# Aleya Apparels Ltd.

6 November 2023

## 2. Observation:

Building -1

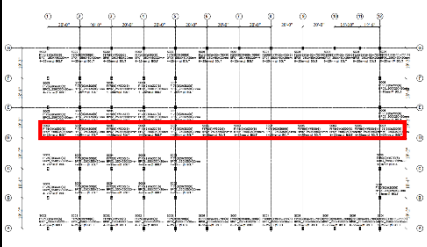
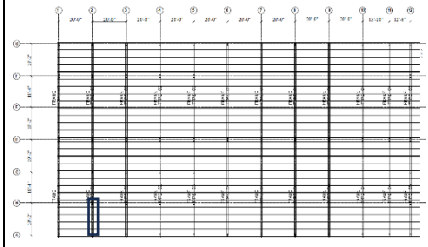
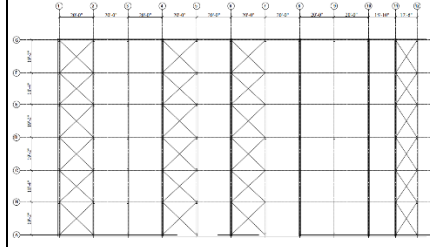
Observation-1: Design report needs to be revised.

**Description:** A set of design reports have been prepared for Building-1 where detailed calculations were not provided for adequacy of foundation and connections. Moreover, the foundation system for 3 storied masonry structure is not clear as it is adjacent to steel column. A qualified building engineer is required to investigate the foundation system of the load bearing wall adjacent to the main building and prepare accurate as-built documents. The building engineer is required to incorporate detailed calculations in the design report. Submit the revised design report to the RSC for review.

SL No.	Observation	Action Plan	Timeline
01.	Design report needs to be revised (Building-1)	The building engineer is required to incorporate all necessary calculations in the design report and add foundation adequacy for the masonry structures. Submit the revised design report to the RSC for review.	within 6 weeks

<p>Column layout plan</p>	<p>Rafter &amp; purlin Layout</p>	<p>Bracing layout</p>

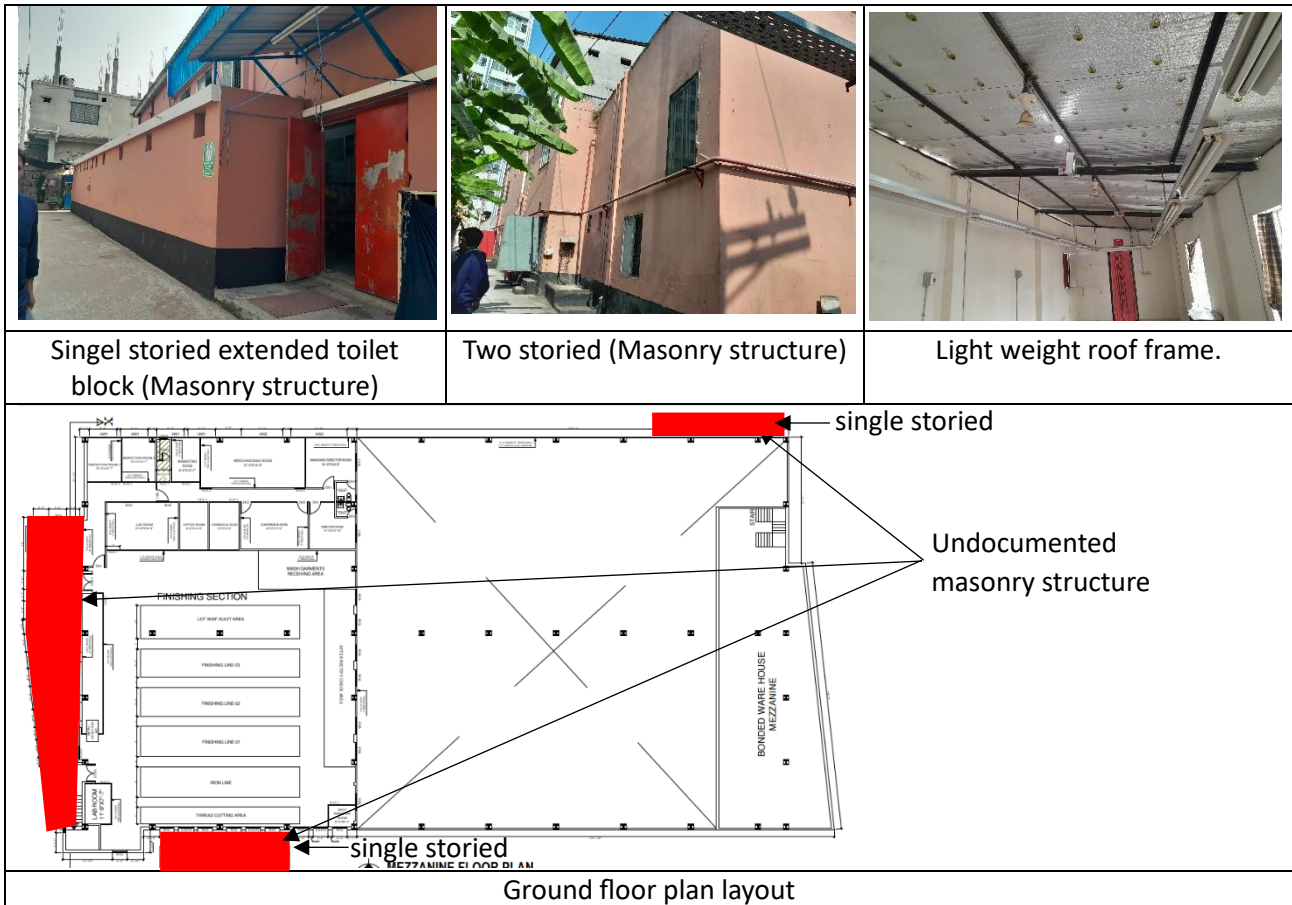
**Observation-2: Mismatch in between as-built drawing and on-site condition.**

**Description:** During inspection some mismatches were found between structural drawing & on-site condition.

1. The flange of SC3 steel column was found 150 instead of 175.
2. The flange of R1 steel rafter was found 175 instead of 200.
3. Cable bracing diameter was found 12 mm instead of 16 mm.

02.	Design report needs to be revised (Building-1)	Carry out remediation work if required.	within 6 months
03.	Mismatch in between as-built drawing and on-site condition. (Building-1)	The building engineer is required to survey the structure and produce accurate as-built structural drawings.	within 6 weeks
04	Lack of design documents for extended masonry structures. (Building-1)	The building engineer is required to prepared design report and as-built drawing for masonry structure and submit to RSC for review.	within 6 weeks
